# Access Compliance Report

## Public Rights-of-Way

Intersection ID: 11882	Main Street: N_PINE_ST	Cross Street: W_5TH_ST	Location:	N
ADA ID: 0ED5239B0FA5	Ramp Type: Perp	Initial Pass/Fail: Pass	Overall Compliance: No	Severity Score: 5
Codes/Mitigation Info/Possible Solution		Field Measurements/Component Compliance

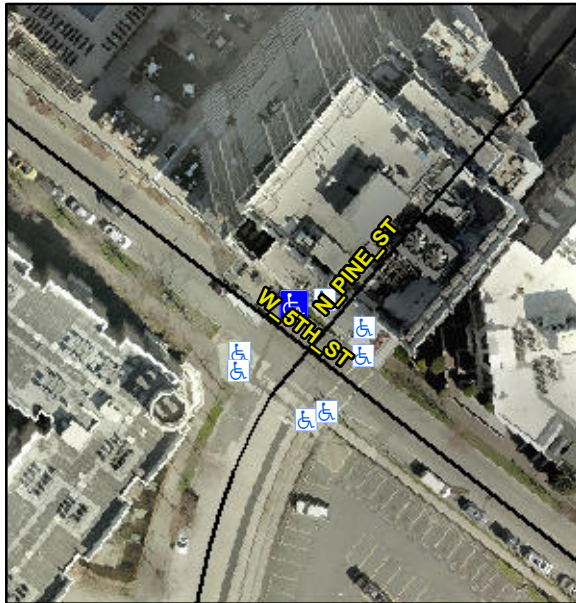
**Not Found, R304.2.2-Perp, R304.3.2-Para, R304.2.3**

Compliance	Description	Data	Compliance	Description	Data
N/A	Ramp Length (in)	73.0	Yes	Ramp Slope (%)	5.9
Yes	Ramp Width (in)	49.0	Yes	Ramp XSlope (%)	0.4
Yes	Flare Type L	Curbed_NoWalkSurface	No	Flare Type RT	N/A
Yes	Flare Slope LT (%)	N/A	N/A	Flare Slope RT (%)	N/A
N/A	Flare Traversable LT?	No	N/A	Flare Traversable RT?	No
Yes	Landing Length (in)	60.0	Yes	DWS Provided?	Yes
Yes	Landing Width (in)	49.0	Yes	DWS Contrast?	Yes
No	Landing Slope (%)	2.2	Yes	DWS Length (in)	24.0
Yes	Landing X Slope (%)	0.5	Yes	DWS Full Width?	Yes
N/A	Landing Curb? (Y/N)	No	Yes	DWS Offset (in)	0.0
N/A	Shared Landing?	Yes			
Yes	Gutter Ponding?	No	Yes	Gutter Slope (%)	2.2
Yes	Gutter Lip Ht (in)	0.0	Yes	Gutter X Slope (%)	2.0
N/A	Painted X Walk1?	No	N/A	Painted X Walk2?	N/A
	X Walk 1 Direction	To SW		X Walk 2 Direction	N/A
N/A	X Walk 1 Width (in)	N/A	N/A	X Walk 2 Width (in)	N/A
	X Walk 1 Slope (%)	2.5		X Walk 2 Slope (%)	N/A
	X Walk 1 X Slope (%)	2.5		X Walk 2 X Slope (%)	N/A

**Remove & Replace Entire Ramp.**
